# PacifiCorp - Stakeholder Feedback Form

## 2021 Integrated Resource Plan

**\*IRP Topic(s) and/or Agenda Items:** List the specific topics that are being addressed in your comments.  
CPA, Battery Storage

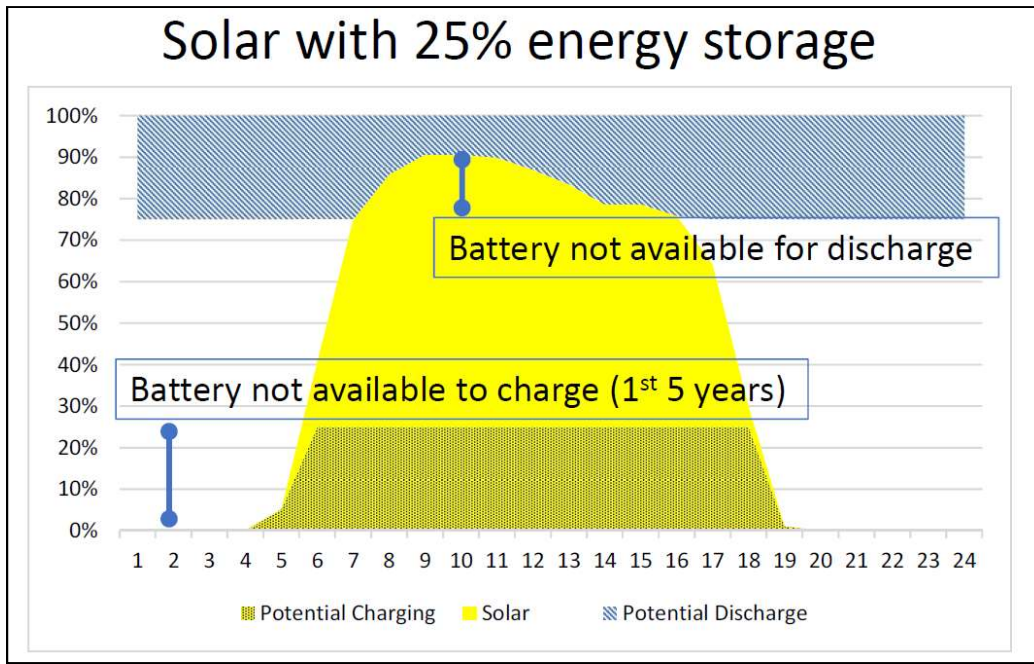
2. See page 30 of the DSM I and III CPA chapter from the 2019 IRP. What does it mean for a DR pricing program to have a useful life of ten years? What is the reasoning for using a ten year lifespan?

Demand-side management (DSM) options are assumed to have both one-time startup costs and ongoing annual costs. Essentially, a “program life” assumption is used to amortize one-time costs over the period for which the pricing option might be offered. The 10-year assumption reflects that PacifiCorp would likely offer a new Class 3 DSM rate option for a number of years, but that over time, the rate may need to be redesigned or discontinued based on changes in enabling technology options and adoption, customer preferences, resource needs and value, or other considerations.
